SUBJECT: Contract Number W912P8-09-D-0046 0008, WBV-14c.2 - Westwego to Harvey Canal, Hurricane Storm Damage Risk Reduction System, New Westwego P.S. to Orleans Village, Phase 2, First Lift Levee and Floodwalls at Westminster Pumping Station, Jefferson Parish, LA

AMENDMENT OF SOLICITATION/MODIFICATION OF CONTRACT

CO-001 Government Furnished Sheet Piling

Contract W912P8-09-D-0046 0008, WBV-14c.2 - Westwego to Harvey Canal, Hurricane Storm Damage Risk Reduction System, New Westwego P.S. to Orleans Village, Phase 2, First Lift Levee and Floodwalls at Westminster Pumping Station, Jefferson Parish, LA is hereby modified to remove approximately 2,346 SF of Contractor Furnished PZ-27 Sheet Piling and replace with 2,520 SF of Government Furnished PZ-27 Sheet Piling.

SHEET IDENTIFICATION
C-08

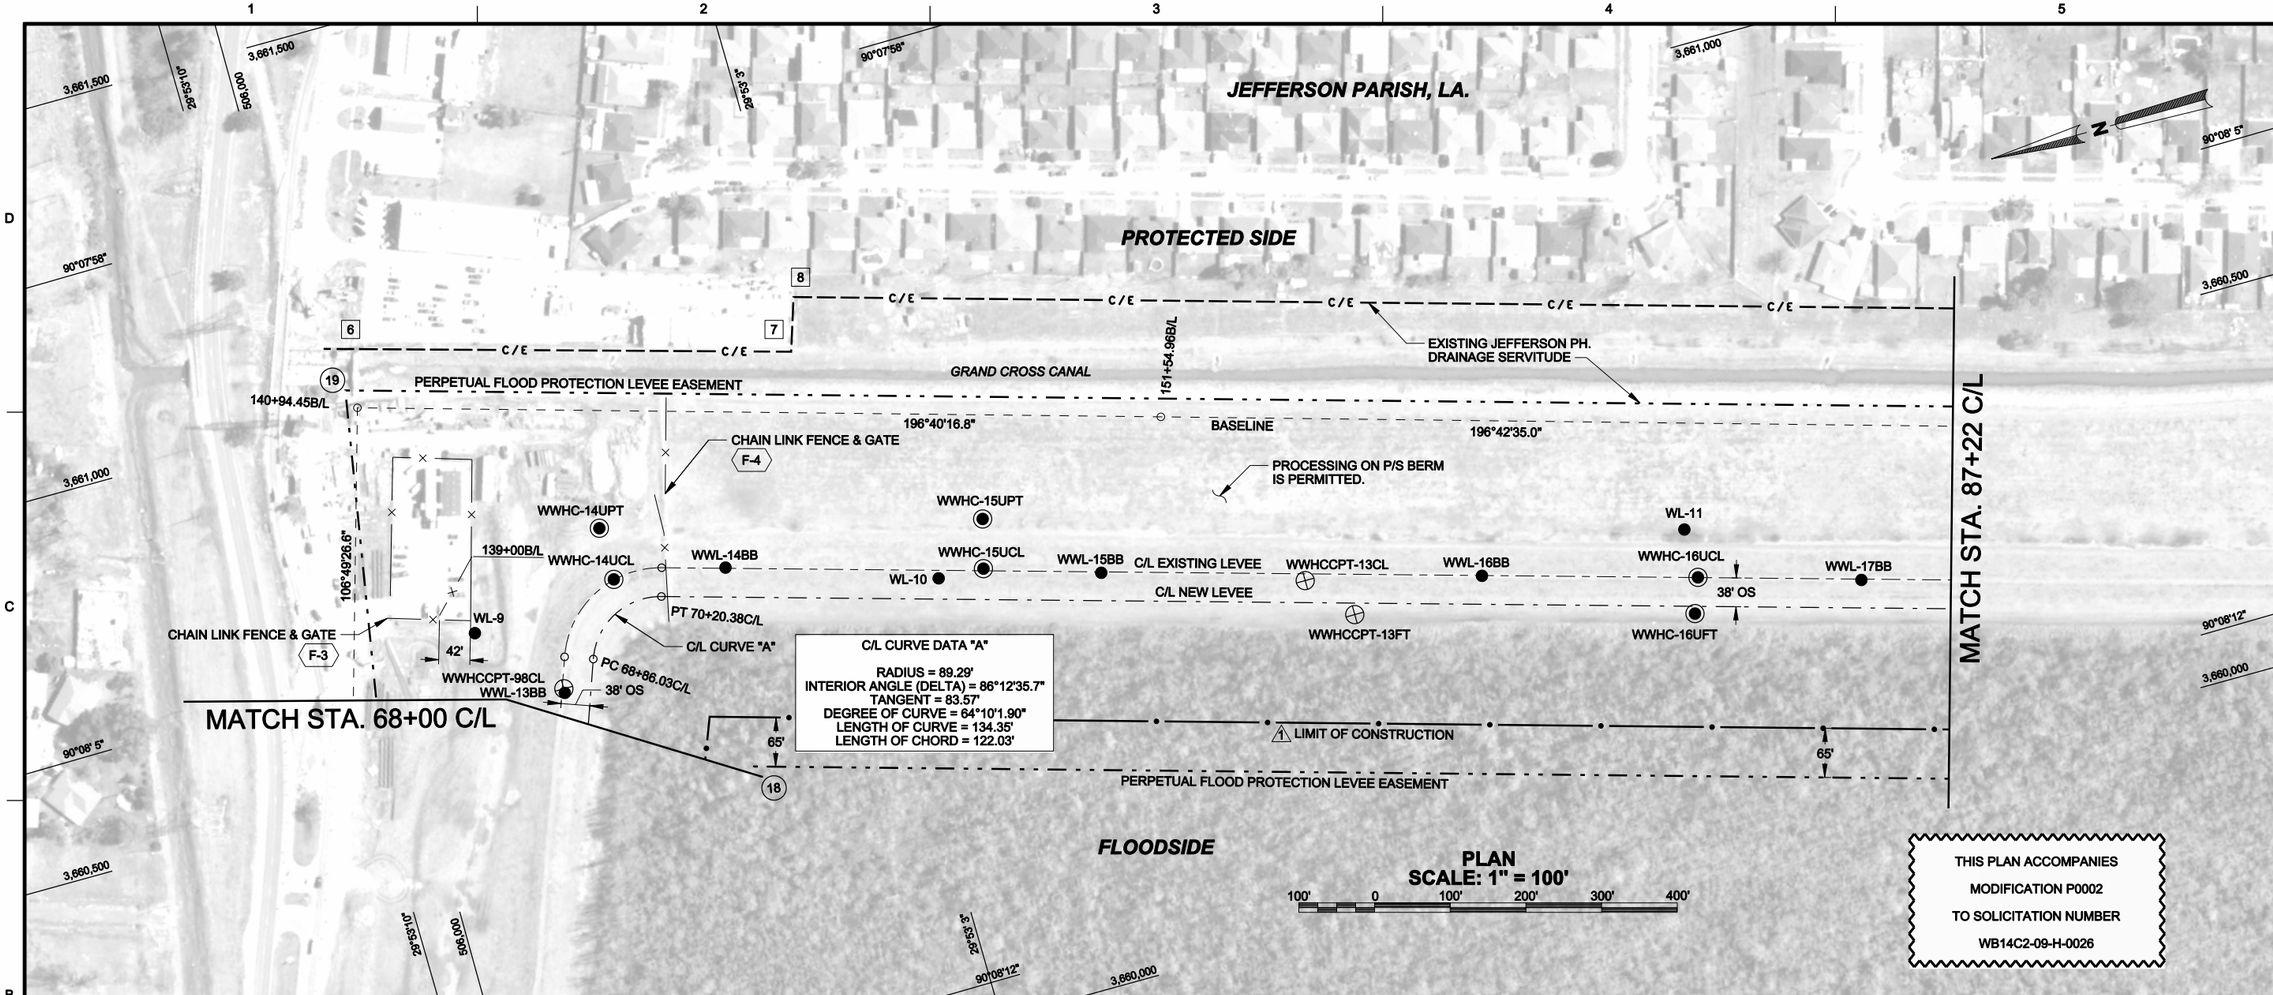
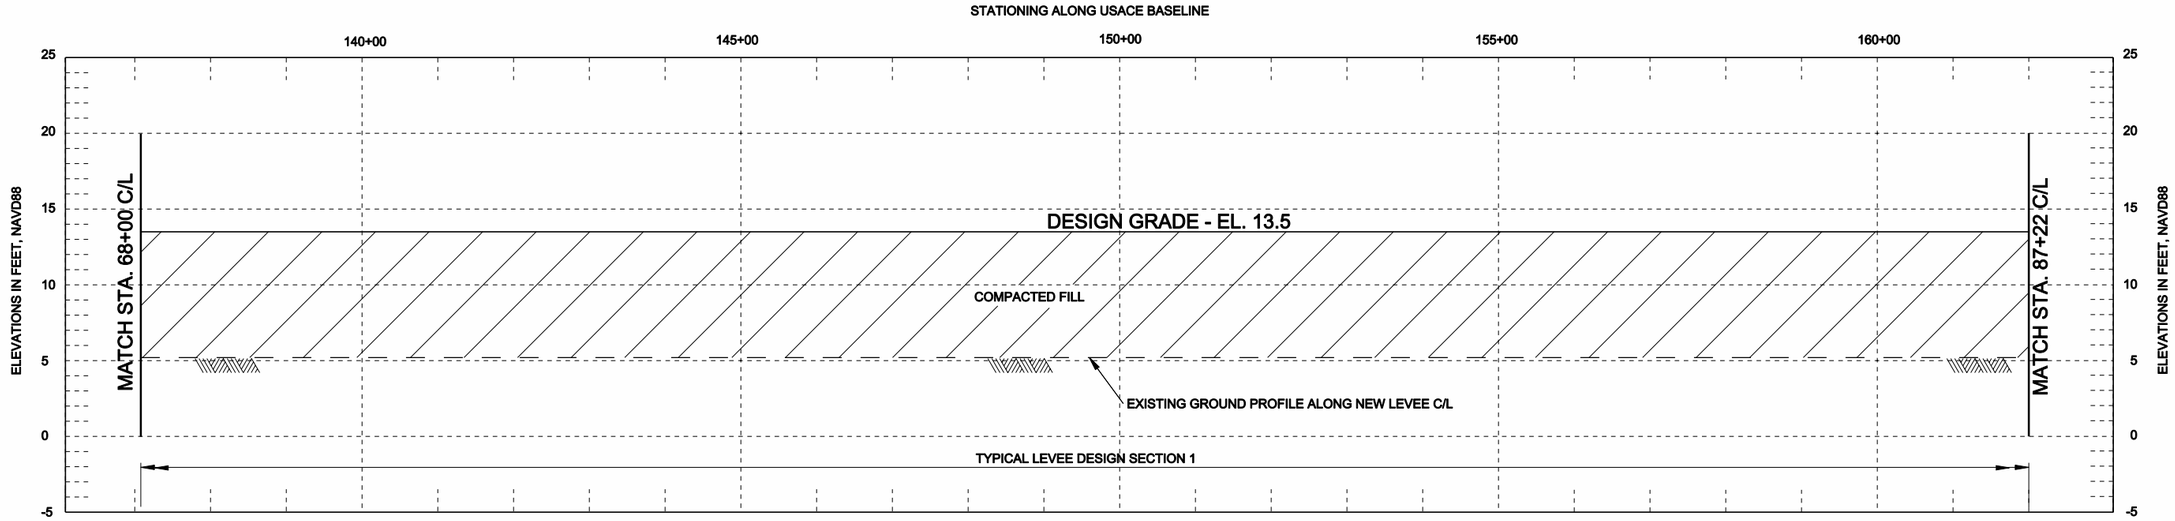
MARK	DESCRIPTION	DATE	APPR.
1	MOD. # P0002 - ADDED FLOOD SIDE LIMIT OF CONSTRUCTION.	04/05/11	B.J.L.

SHEET IDENTIFICATION
C-09

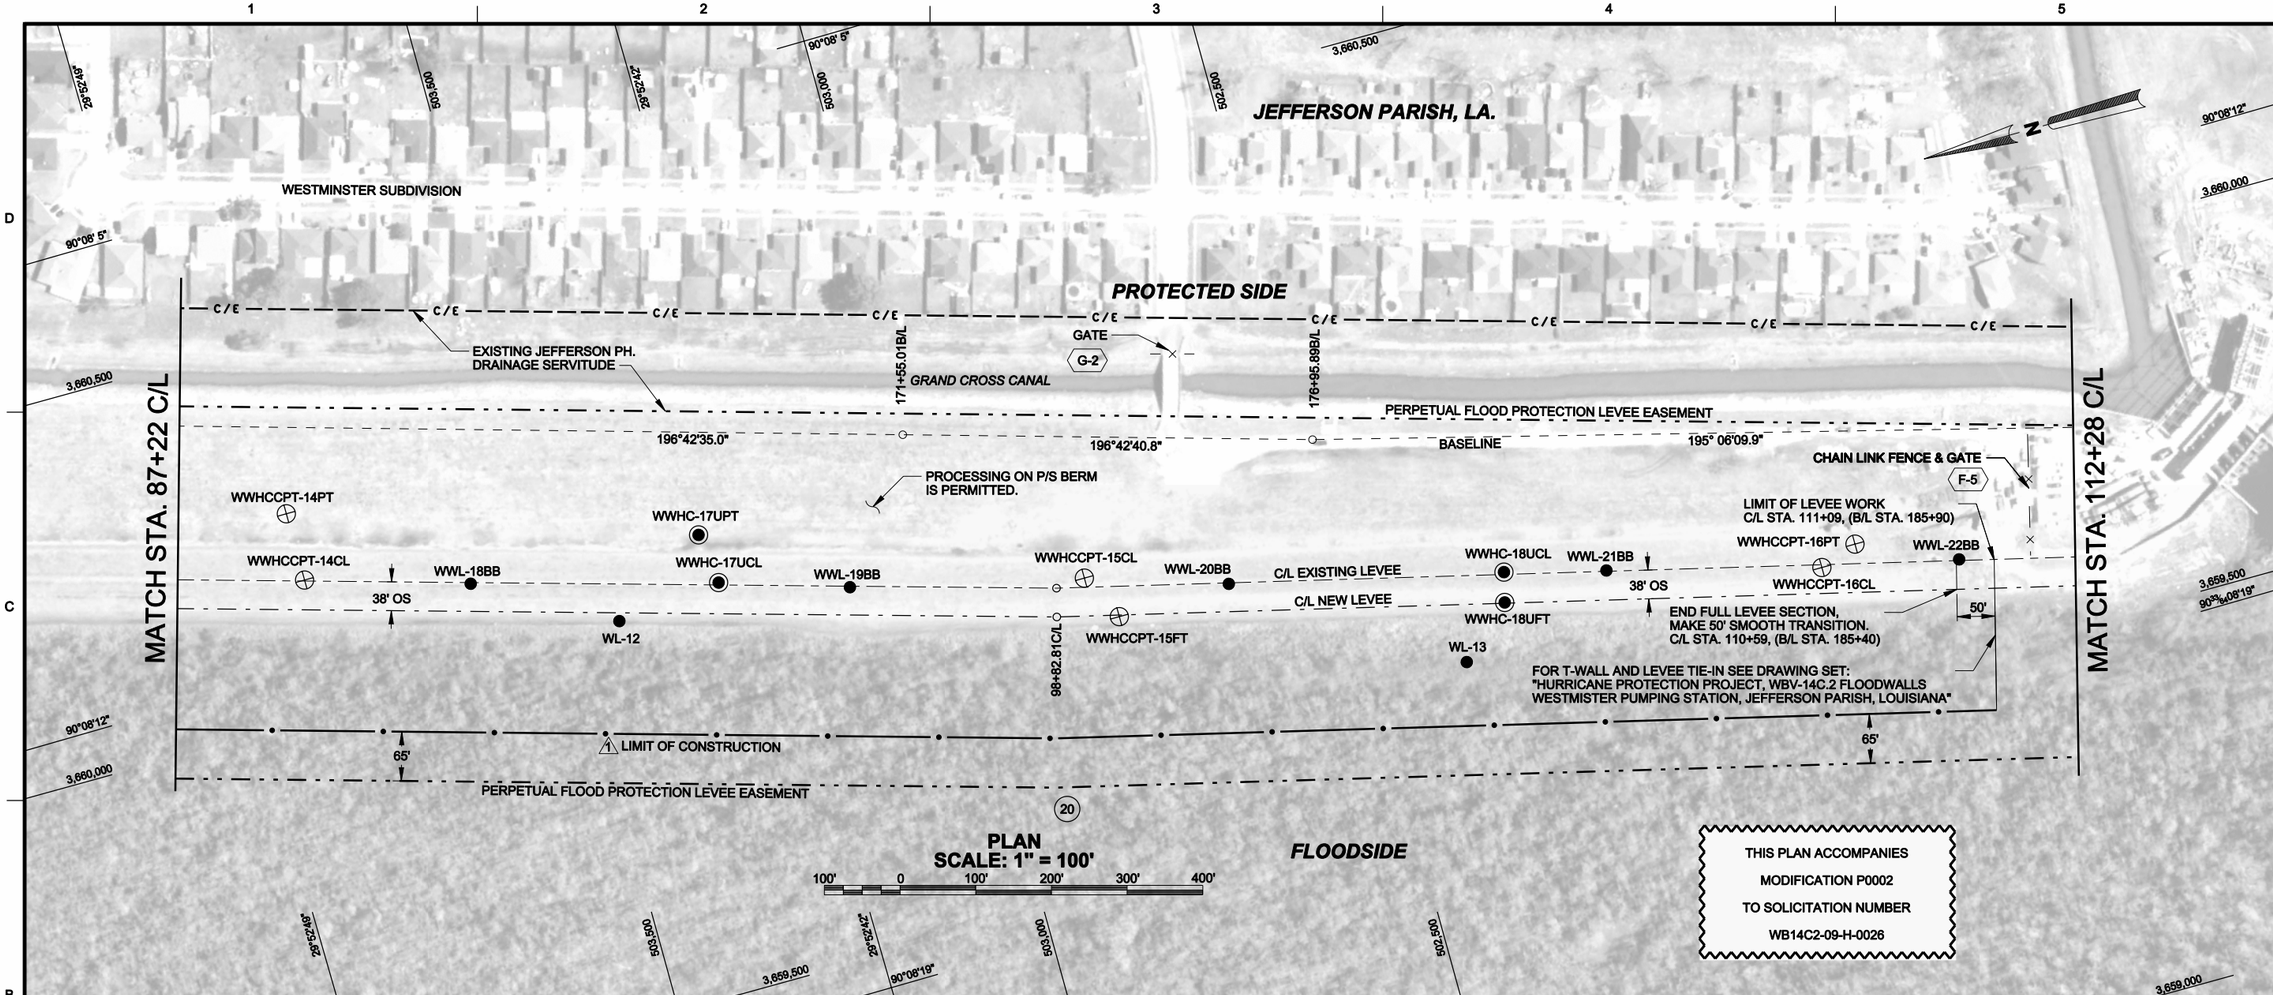
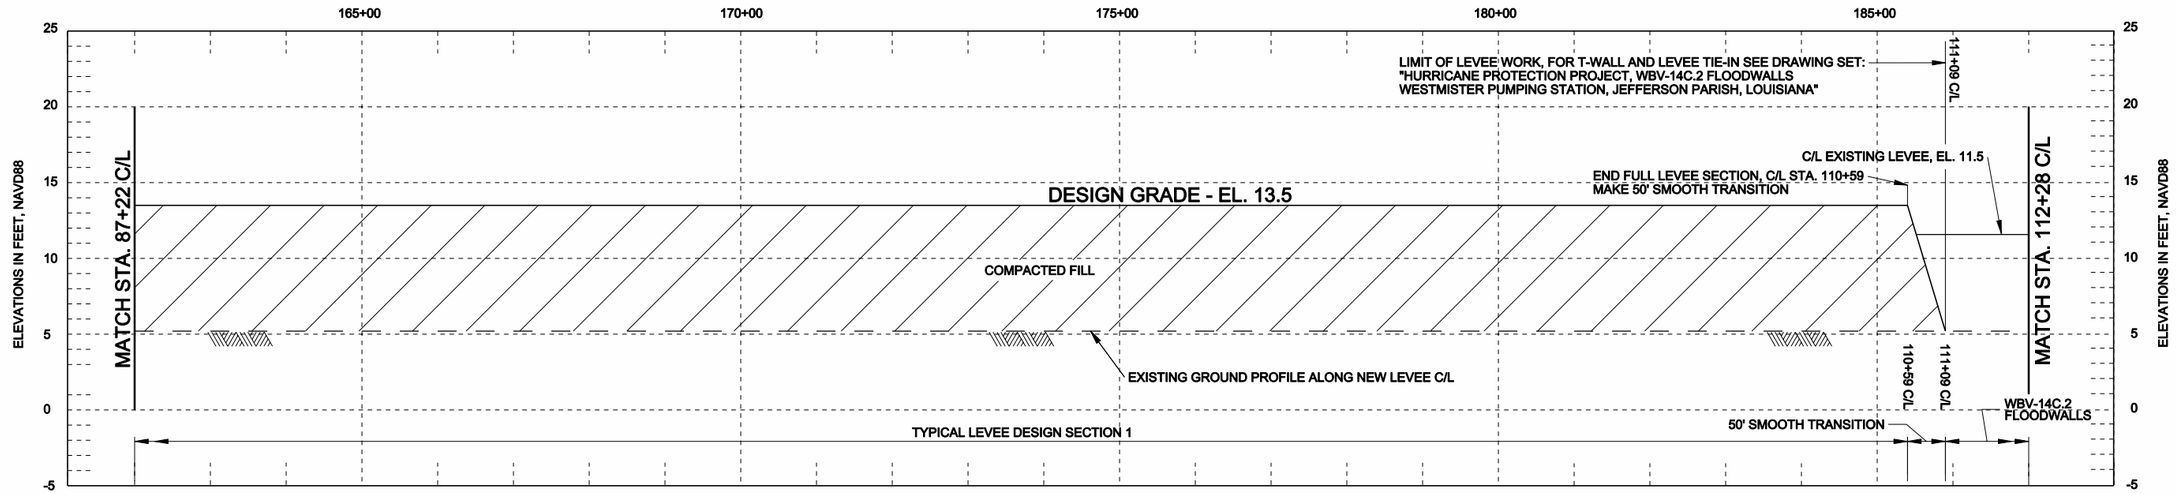
MARK	DESCRIPTION	DATE	APPR.
1	MOD. # P0002 - ADDED FLOOD SIDE LIMIT OF CONSTRUCTION.	04/05/11	B.J.L.

SHEET IDENTIFICATION
C-10

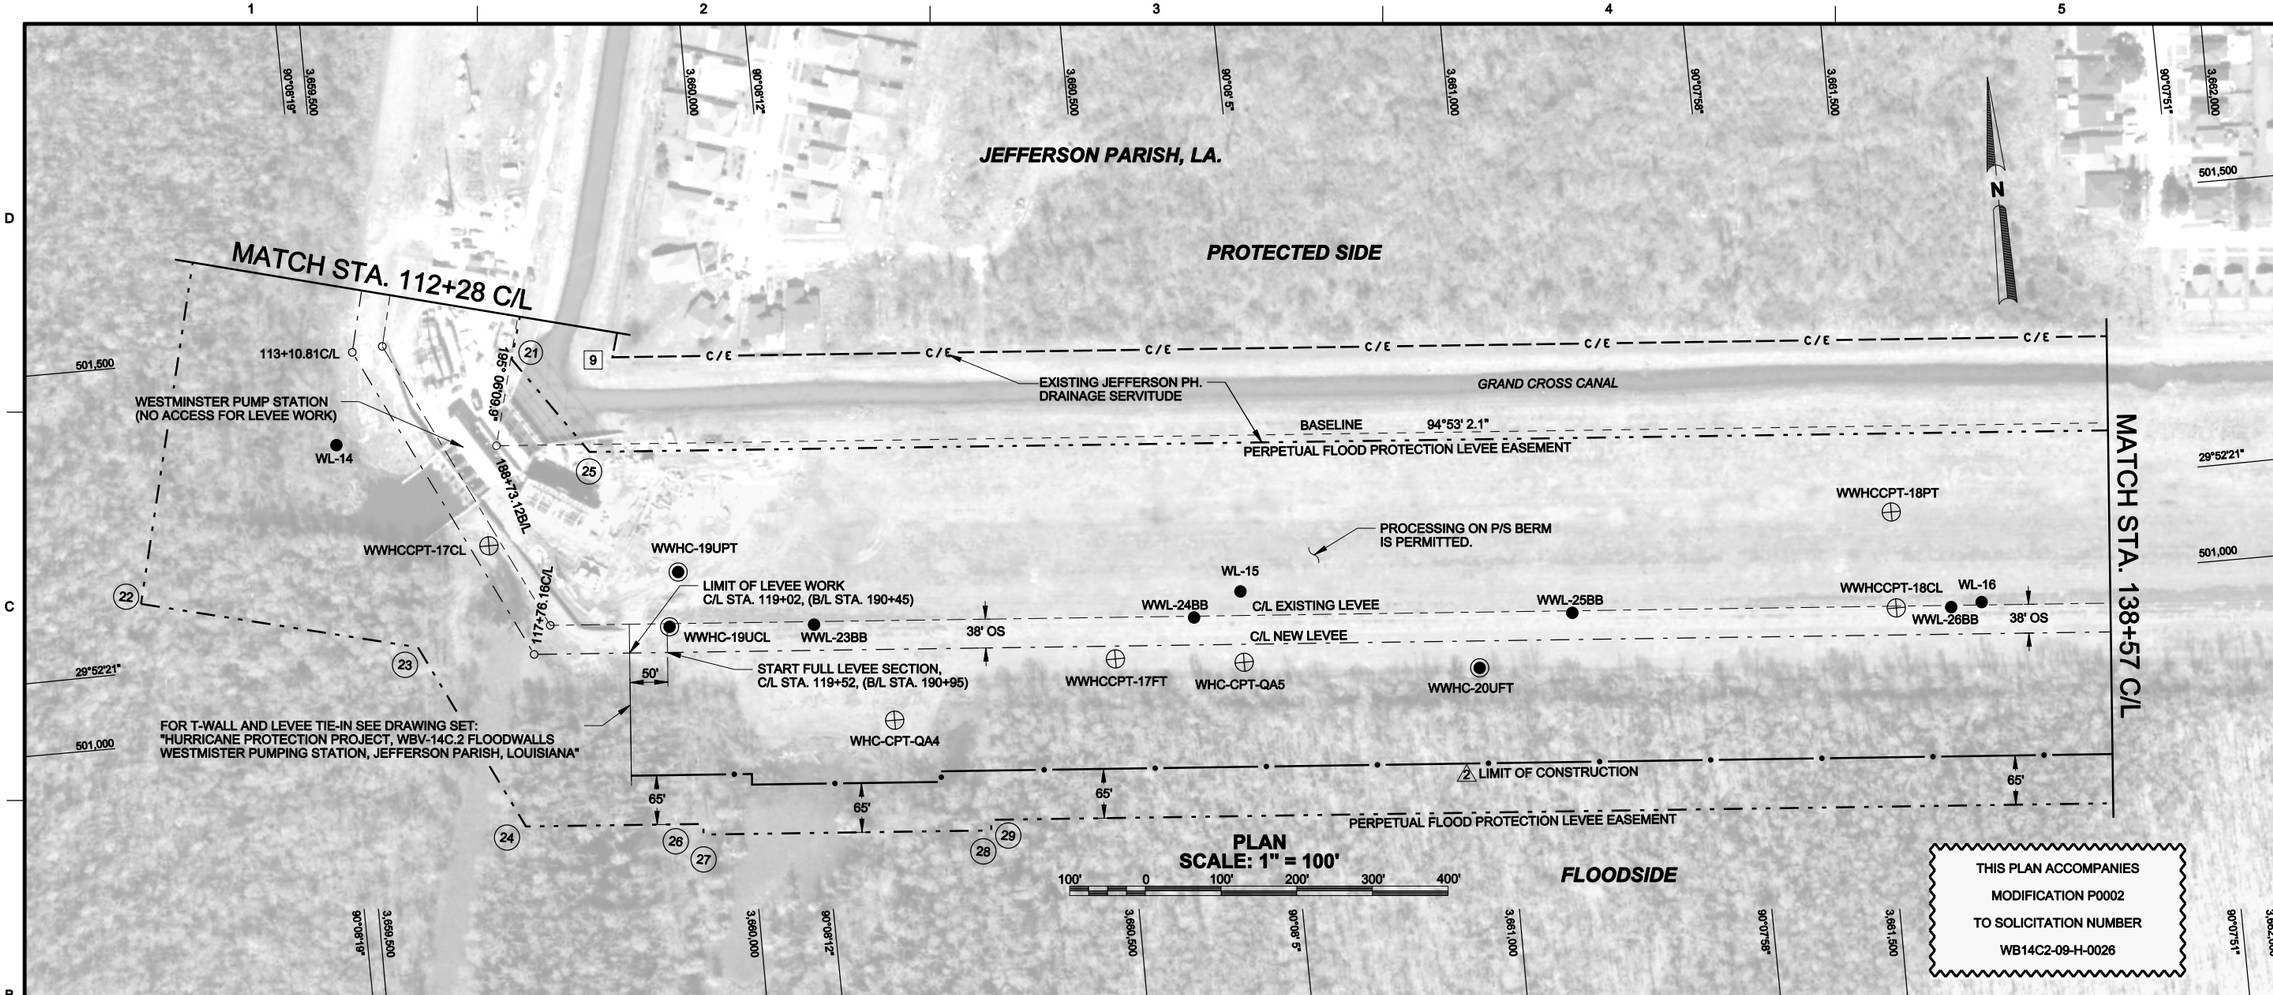
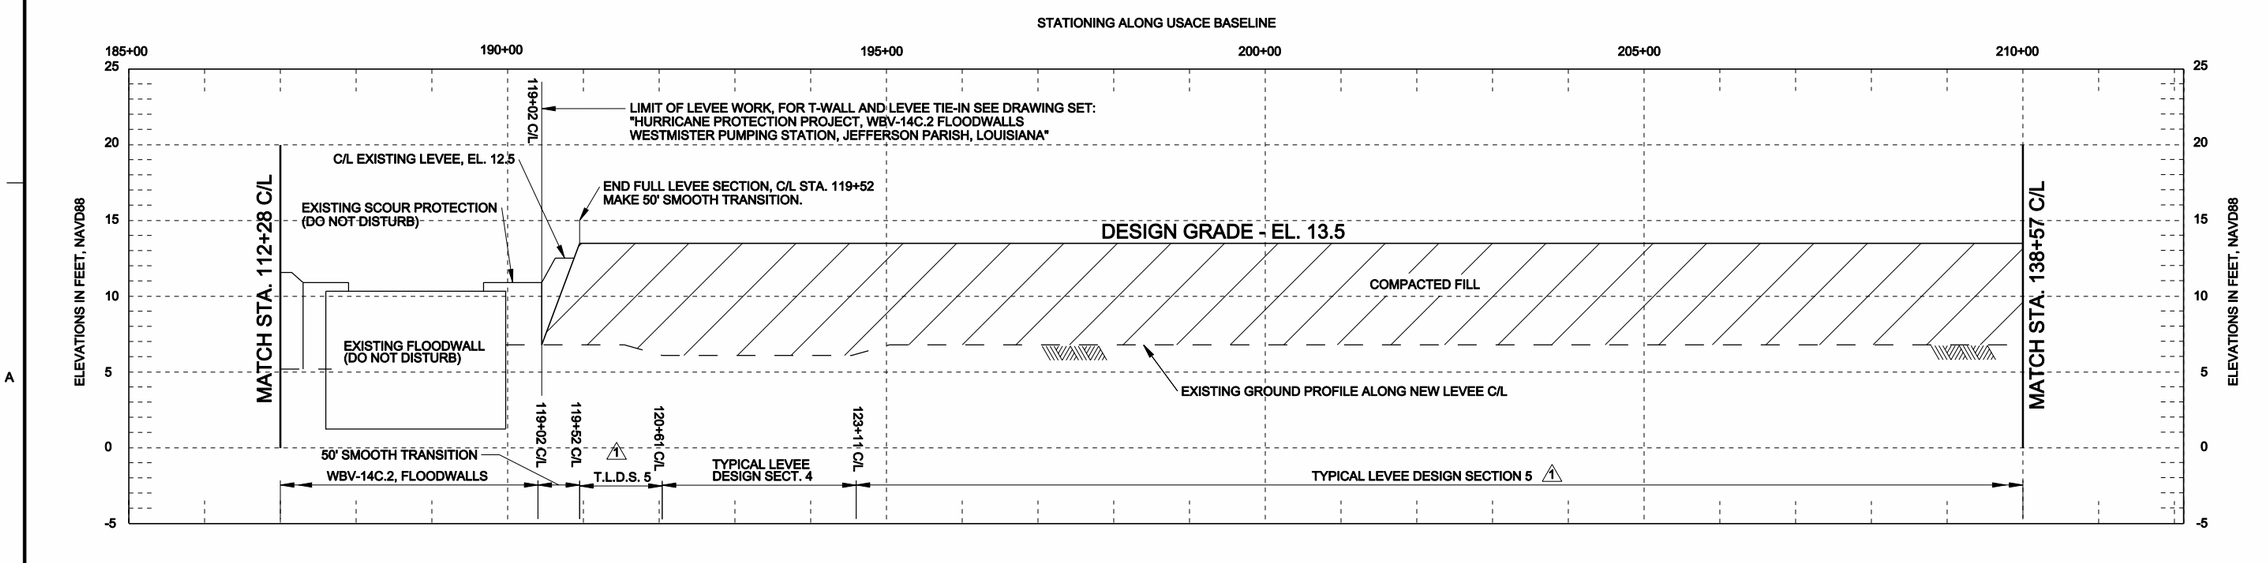
MARK	DESCRIPTION	DATE	APPR.
2	MOD# P0002 - ADDED FLOOD SIDE LIMIT OF CONSTRUCTION.	04/05/11	B.J.L.
1	MOD# P0001 - REVISED TYPICAL SECTION LIMITS IN PROFILE.	03/15/11	B.J.L.
